UNITED STATES  
DEPARTMENT OF THE INTERIOR  
BUREAU OF LAND MANAGEMENTFORM APPROVED  
OMB NO. 1004-0135  
Expires: July 31, 2010**SUNDRY NOTICES AND REPORTS ON WELLS**  
**Do not use this form for proposals to drill or to re-enter an abandoned well. Use form 3160-3 (APD) for such proposals.**5. Lease Serial No.  
NMSF078336B

☐ Oil Well ☒ Gas Well ☐ Other8 Well Name and No.  
BARRETT A 13

BP America respectfully requests permission to plug and abandon the subject well. We have evaluated this well and find no further potential. Please see the attached P&A procedure and wellbore diagrams.

Re: Permanent Abandonment  
Well: 13 Barrett A

## Proposed Wellbore Diagram

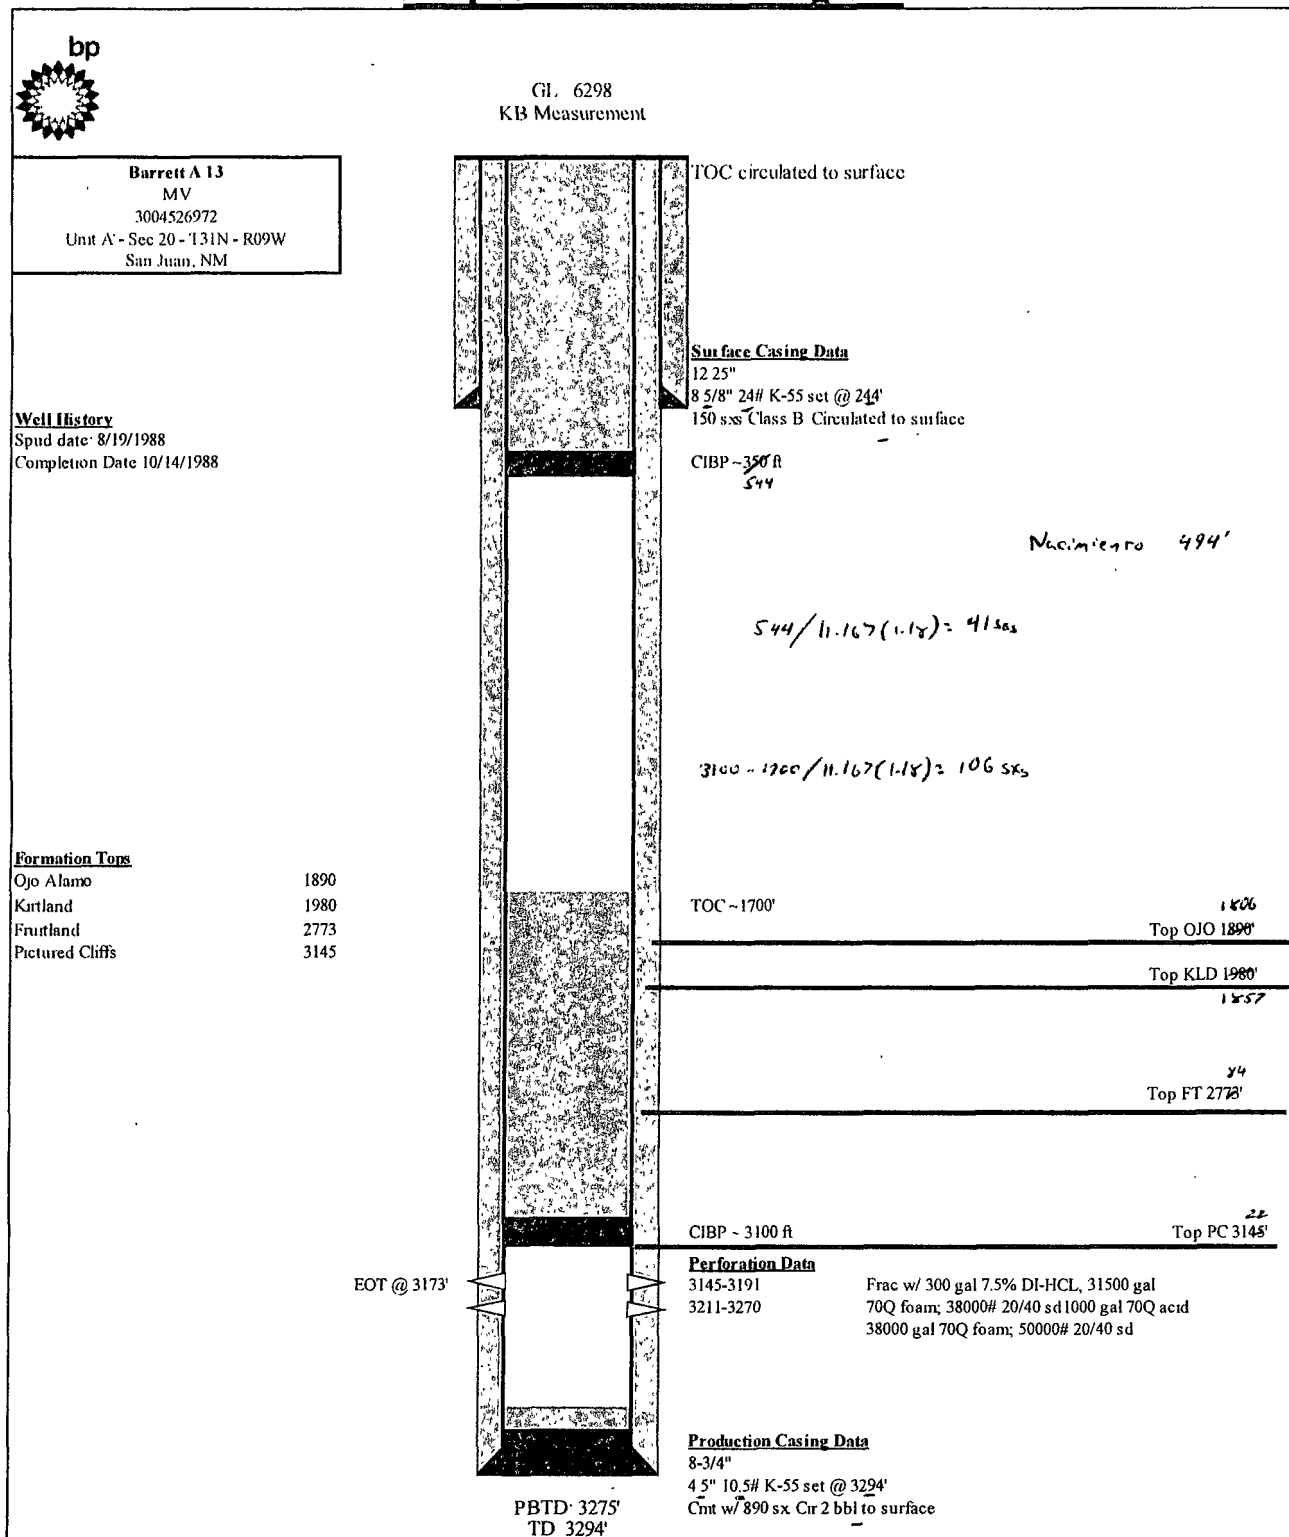
1. Plugging operations authorized are subject to the attached "General Requirements for Permanent Abandonment of Wells on Federal and Indian Lease."
2. Farmington Office is to be notified at least 24 hours before the plugging operations commence (505) 564-7750.
3. The following modifications to your plugging program are to be made:
  - a) Place the Nacimiento/Surface plug from 544' to surface.
